#### Planning Staff Report to Design Review Board - Urban January 21, 2022

Docket Number: 21-945

**Property Location:** 40 W. Broad Street

**Proposal:** Construction of new structure and amenities in courtyard, exterior

VILLAGE GREEN - VIEWED FROM S. MAIN STREET SIDEWALK

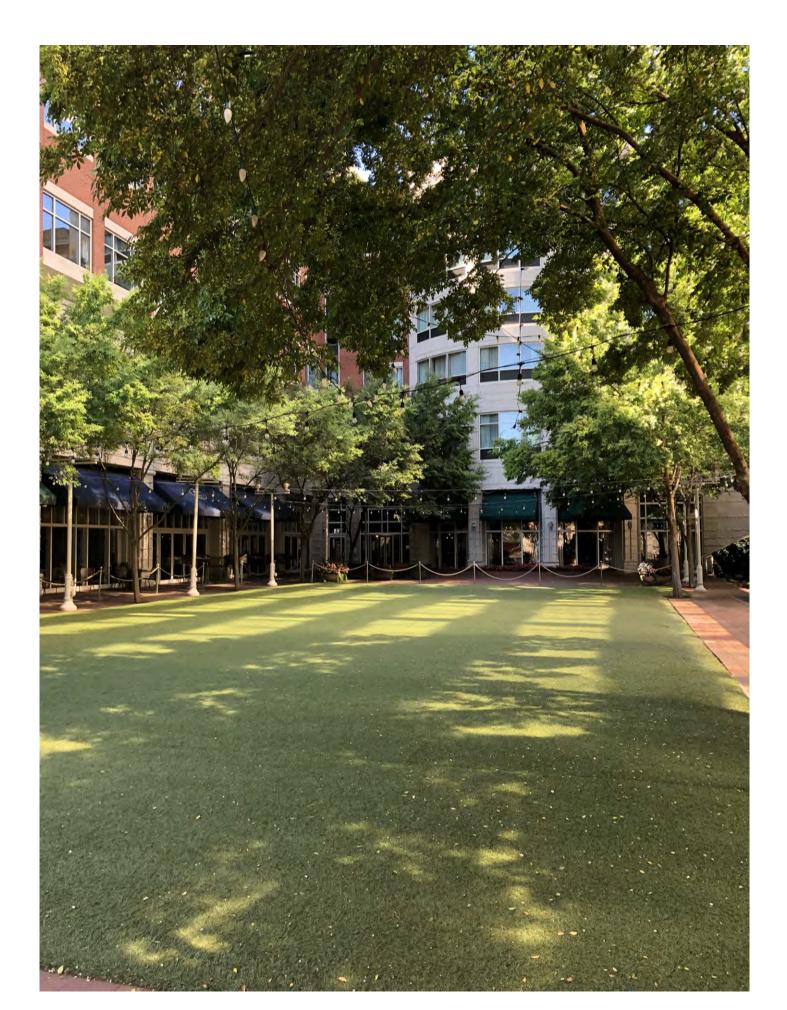
Staff finds that the revised roofing material selection, paired with the additional rendering of the view from Main Street satisfy previous concerns regarding visibility of the roof from the public realm.
